**DEPARTMENT OF DEVELOPMENT SERVICES – PLANNING DIVISION**  
**REPORT: Inland Wetlands & Watercourses Permit, 2 Maxim Rd.**  
for consideration September 22, 2020

**STAFF REPORT**

**PROJECT:** Bridge Construction at  
2 Maxim Rd.  
PARCEL ID: 315-693-002  
ENERGOV ID: P&Z-COMM-2020-0156

Figure 5. Enlargement of Site Plan, shows new bridge and driveway location across existing inland wetlands, as flagged by Soil Scientist.

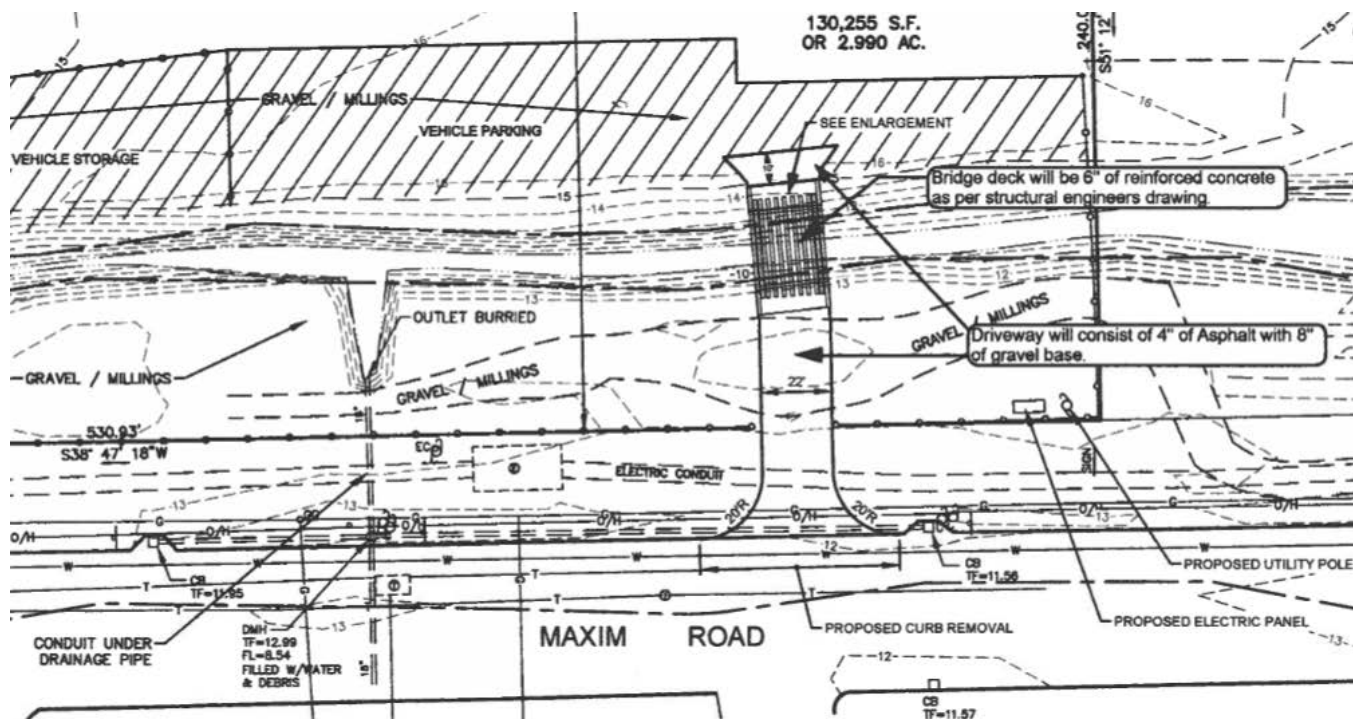
Although portions of the bridge have been installed, the Structural Engineer's report (included with Attachment #1) indicates some corrective actions are recommended in order to make the bridge structurally adequate for anticipated vehicles. It is Planning Staff's understanding that such corrective measures would need to be taken as part of the Building Permit review. The Commission may wish to schedule a public site walk as part of the review of this application in order to gain a better understanding of impacts that have been made to wetlands and upland review area.

To address concerns raised by the City Engineer, it is recommended that the Applicant be required to work with a Qualified Environmental Scientist to clear the drainage swale on this property and near the culvert of Phragmites, debris, and other plants growing within the water flowline which obstruct drainage, likely contributing to flooding issues in the area.

KEY PLAN

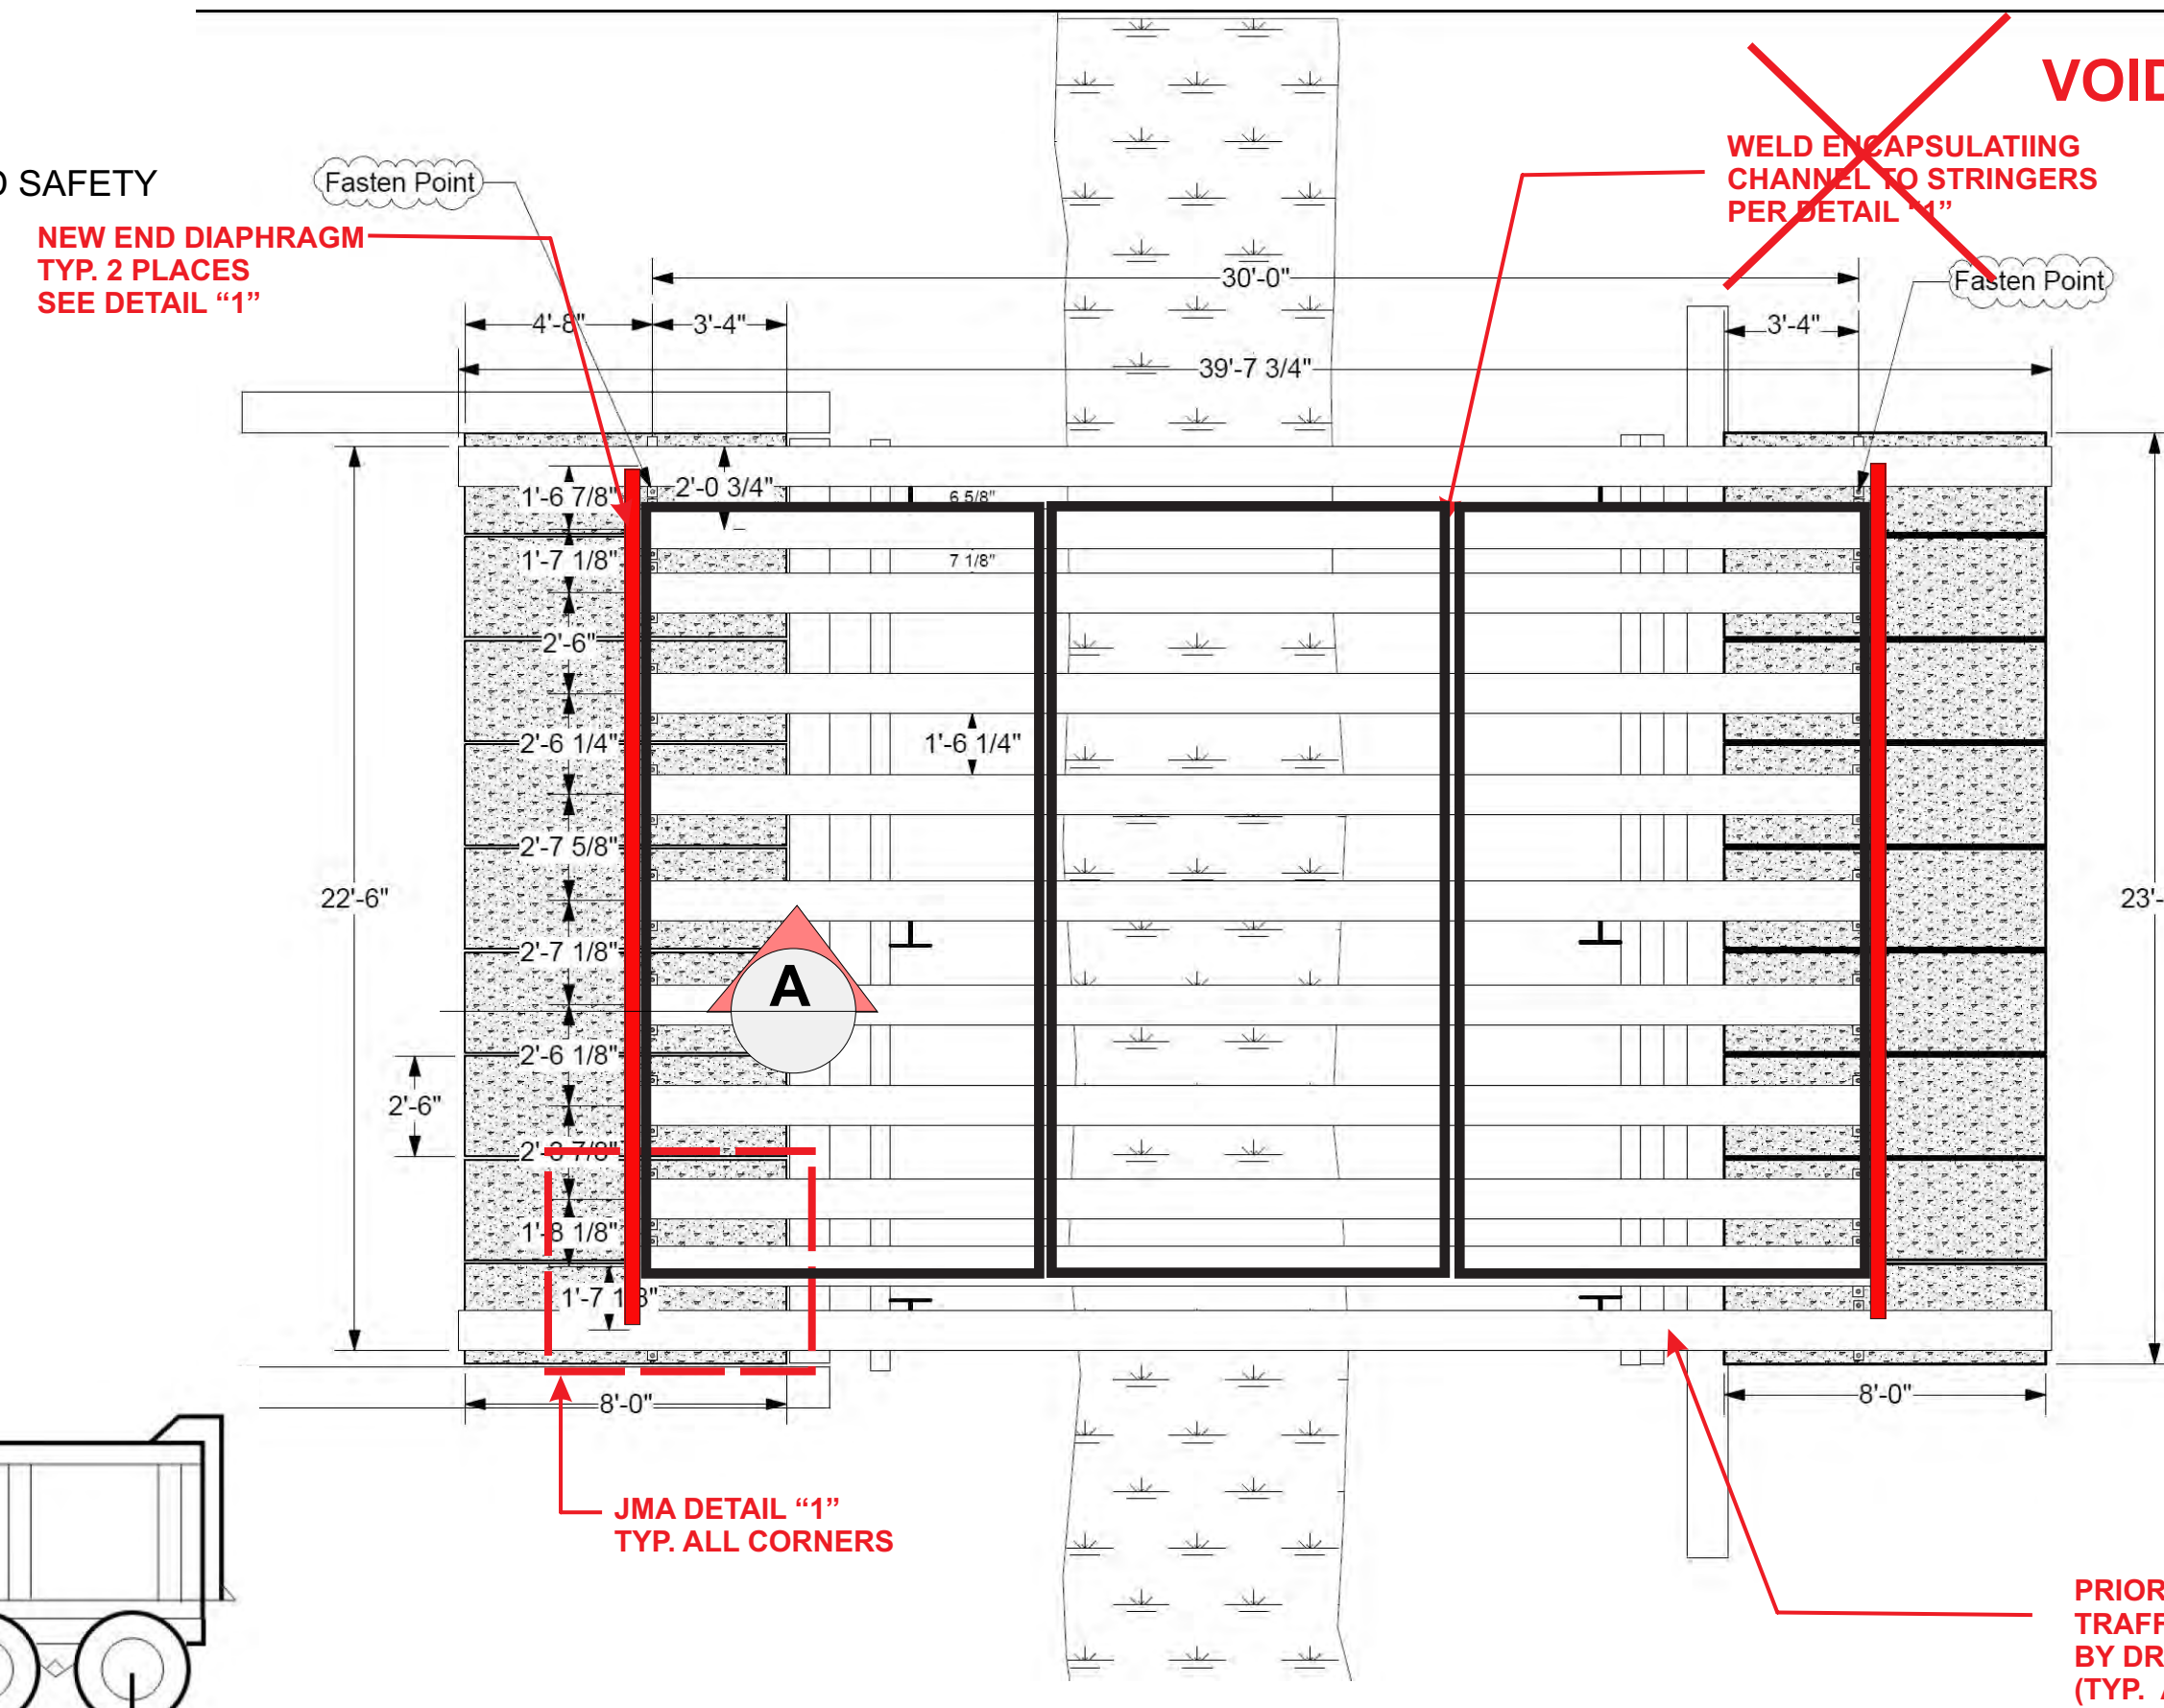
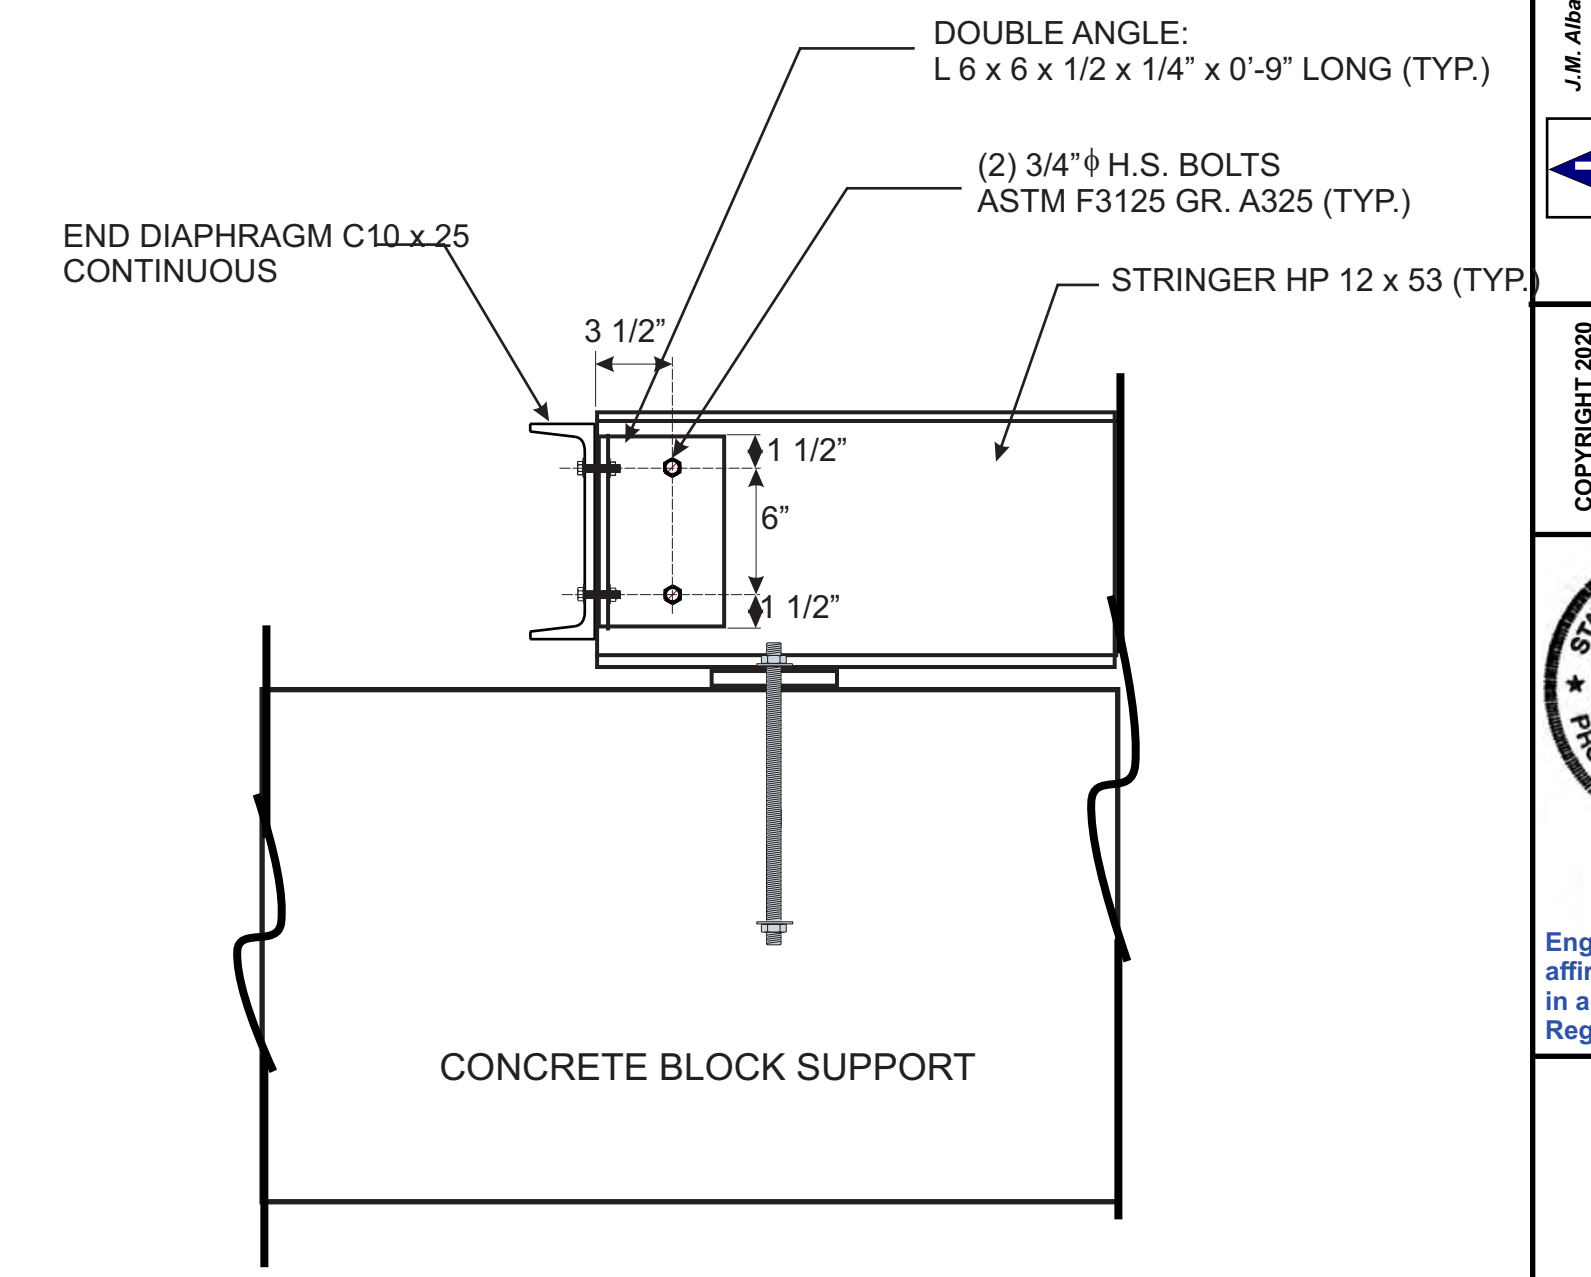
- Structural Design Drawing of the bridge, certified by a structural engineer, indicating design will withstand the loads of the intended users (dump trucks, heavy equipment, etc.)
  - Include a cross-section at the wetlands/watercourse crossing.

- Revised Site Plan to include the following:
  - Modifications to proposed bridge, designed/certified by a structural engineer

The set stringers will require the top flange to be laterally braced at midspan to prevent lateral buckling and meet the bending strength requirement. The lateral bracing would be accomplished by welding the boundary 6" deep channel around the concrete deck to the stringers.

At each abutment the stringers should be ties together (cross frame / diaphragm) to prevent axial rotation (twisting) of the stringers on the bearing support.

The bridge is existing and has been inspected by a Connecticut licensed structural engineer. He has completed a 14 page report and a two page plan showing the bridge to be structurally sound and having the load capacity to support large heavy truck traffic. The bridge will need a concrete deck which will be poured in place to be complete. We will obtain a building permit to pour the concrete deck prior to any work being started.

See Structural Engineers Plan
